SERVICE LETTER

No. 667A

Piper Aircraft Corporation

Stabilator Attachment Bolts

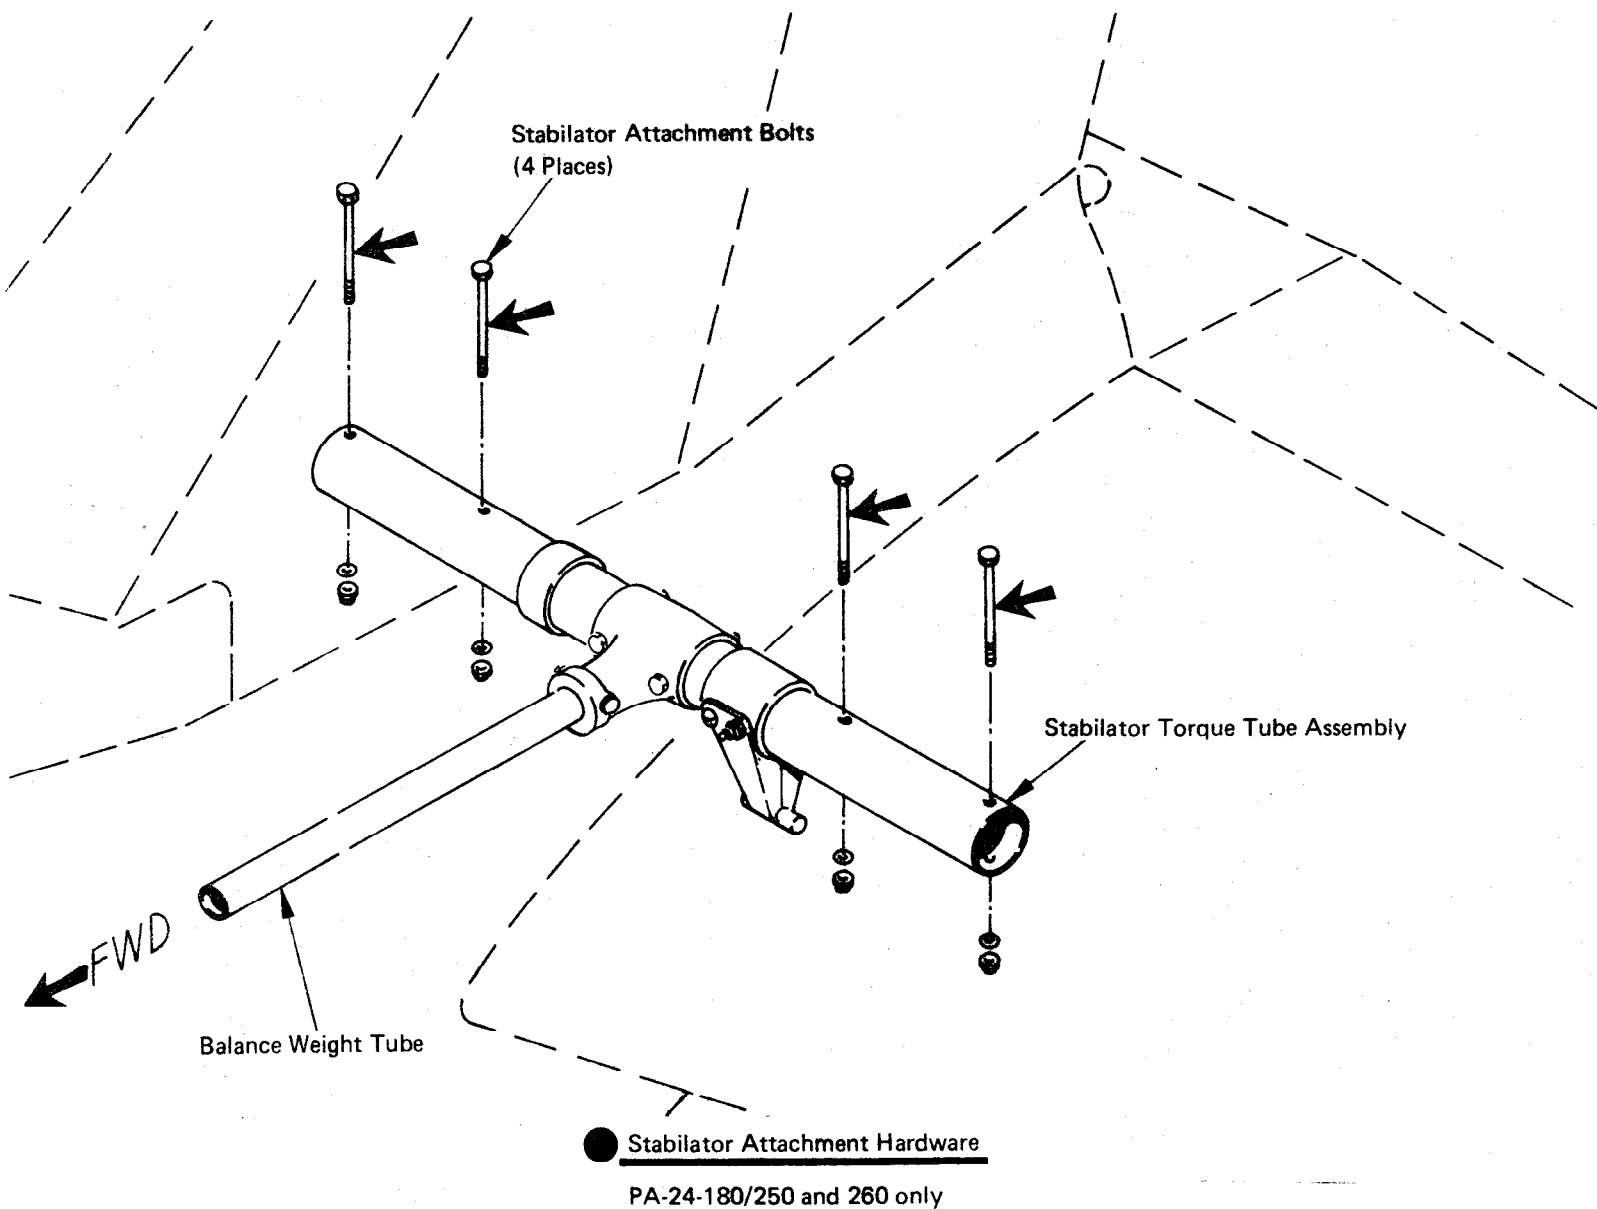
1. Revised Compliance Time, below.
2. Added alternate replacement hardware material, refer to attached sketch/instruction sheet for new replacement hardware identification data.

Remove existing stabilator attachment bolts, washers and nuts, indicated on sketch, and install new bolts and attaching hardware.
CAUTION: Remove and replace one bolt at a time. Refer to sketch for correct replacement hardware identification and proper assembly of bolts, washers and nuts.

- a. PA-24-180/250 and 260 - torque to 30-40 inch lbs.
- b. PA-23-235/250/250 (Six Place) and PA-24-400 - torque to 60-85 inch lbs.
- c. PA-30 - Refer to the Twin Comanche Service Manual (Section 4 - paragraph 49) which states that the nuts ("holding the stabilator to the torque tube") should "be tightened just enough to take the play out of the washers."

Bolt AN174-C32A P/N 502 329 (Corrosion Resistant) or Bolt AN174-32A P/N 402 329 (Non-Corrosion Resistant)
 Washer AN960-416L P/N 407 585
 Nut MS20365-428C P/N 404 888

PA-23-235/250/250 Six Place, PA-24-400 and PA-30 only

Bolt AN175-C32A P/N 502 342 (Corrosion Resistant) or Bolt AN175-32A P/N 402 342 (Non-Corrosion Resistant)
 Washer AN960-516 P/N 407 566 (PA-23-235/250 and 250 Six Place only)
 Washer AN960-516L P/N 407 586 (PA-24-400 and PA-30 only)
 Nut MS20365-524C P/N 404 889
